TITLE: ZBA 08-15: 1300-1366 S. Finley Road

**VILLAGE OF LOMBARD
INTER-DEPARTMENTAL REVIEW GROUP REPORT**

ZBA 08-15; 1300-1366 S. Finley Road: The petitioner requests that the Village approve the following actions for the subject property located within the R5PD General Residential Planned Development District:

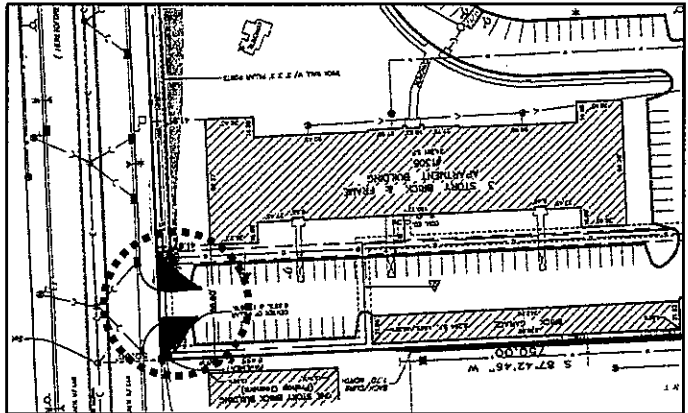
The petitioner is also seeking a variation to allow two (2) of the existing brick pillars at the northern driveway along Finley Road to be within the clear line of sight areas. Pursuant to the Zoning Ordinance, supporting members of a fence in the clear line of sight area shall not be greater than six inches (6") in width. The existing brick pillars are thirty inches (30") in width. The original planned development was silent with respect to fencing and no permit was issued for the wall as permits were not required until 2000.

The above plan shows the location of these pillars within clear line of sight triangles (in red). Currently, the pillar on the southern side of the driveway is of only minor concern regarding visibility as the driveway is right turn in and right turn out only. The pillar on the northern side of the driveway could block some visibility to and from Finley Road. However, the petitioner's proposal will actually increase visibility in the clear line of sight area as the fence will be of open construction.

5. The variation to allow the brick pillars to remain in the clear line of sight area shall be applied only to the two pillars directly adjacent to the northern driveway along Finley Road.

6. In the event that either of the two brick pillars directly adjacent to the northern driveway along Finley Road are destroyed or deconstructed to fifty percent (50%) of their value, they shall neither be reconstructed nor shall any supporting member of the fence greater than six inches (6") in width be constructed within the clear line of sight area.
7. The signs attached to the existing wall shall be removed and shall not be reinstalled on the proposed fence.
